Civic Hospital Neighbourhood Association (CHNA)

Submission regarding File No: D07-12-21-0059 and D07-07-21-0007 Site Plan Control (Master) and Lifting of Holding Zone for Proposed Hospital Site

Figure 5: Study Area Intersections

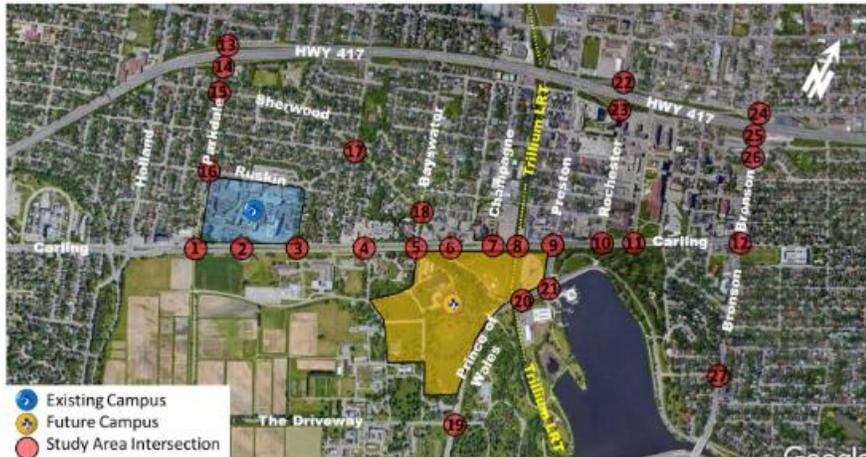
To assist you with identifying some of the streets impacted by the New Campus Development, [Figure 5](#) of the TIA illustrates 25 Study Area Intersections, 12 of which are found within the CHN.

It must be emphasized that Neighbourhood Traffic Calming Studies, a tool repeatedly referred to in the TIA as a means to address **traffic infiltration**, are not the means to mitigate **additional traffic volume** on Sherwood, Parkdale, or any of the streets in the Civic Hospital Neighbourhood (CHN).

CHNA requests a condition, that the TIA should include an evaluation of neighbourhood traffic management needs with the intent of minimizing or mitigating infiltration of traffic generated by the new campus into the Civic Hospital Neighbourhood and those strategies should be implemented before the new campus opens to ensure foreseeable issues are prevented.
